MONTGOMERY COUNTY HISTORIC PRESERVATION COMMISSION
STAFF REPORT

Address:	17201 Norwood Road, Sandy Spring	Meeting Date:	2/21/2024
Resource:	Master Plan Site No. 28/13 <i>Norwood</i>	Report Date:	2/14/2024
Applicants:	Jose Thommanna MCDOT Division of Transportation Engineering	Public Notice:	2/7/2024
Review:	HAWP	Tax Credit:	n/a
Permit No.:	1056978	Staff:	Chris Berger
Proposal:	Lighting installation

MONTGOMERY COUNTY
 DEPARTMENT OF TRANSPORTATION
 DIVISION OF TRANSPORTATION ENGINEERING
 HERITAGE TRIANGLE TRAIL PHASE 1
 DR. BIRD / NORWOOD ROAD
 SHARED USE PATH
 LIGHTING PLAN

Figure 2: The applicant provided this representative photo of the proposed 12-foot tall fiberglass post with “Colonial” light at the top.

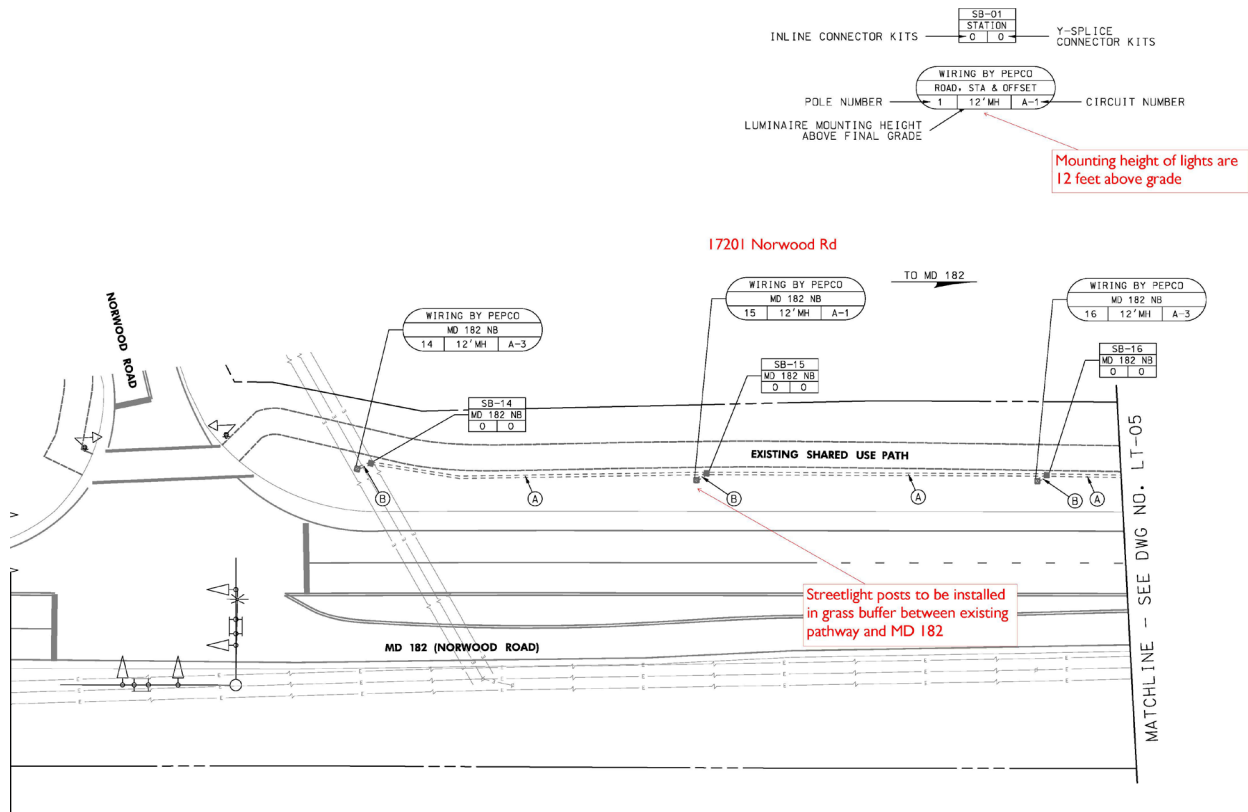
Though they will be 12 feet tall, the lights will be located within the boundary of the Norwood property and will be minimally visible from the historic buildings, in accordance with Chapter 24A-8(b)(1). The main house is the closest building on the property and is approximately 375 feet from the path, so the visible impact of the lights from the historic buildings will be minimal. Further, the Norwood Road cut drops approximately 5 feet before it reaches the path. The deciduous and evergreen trees screen the view of the path from the house so that the lights are partially obstructed from view for the most of the year. In accordance with Chapter 24A-8(b)(2), the simple fiberglass posts with “Colonial” post tops are

compatible with the historic site as they will be a minimal visual presence and have a simple design. The lights will improve the safety for path users in low-light conditions to meet the requirements of Chapter 24A-8(b)(4). MCDOT will need to obtain an easement or other permission by the property owner prior to installation since the work is not occurring within the ROW, but on the Norwood property itself.

1. Applicant shall provide staff with a specification for the light.
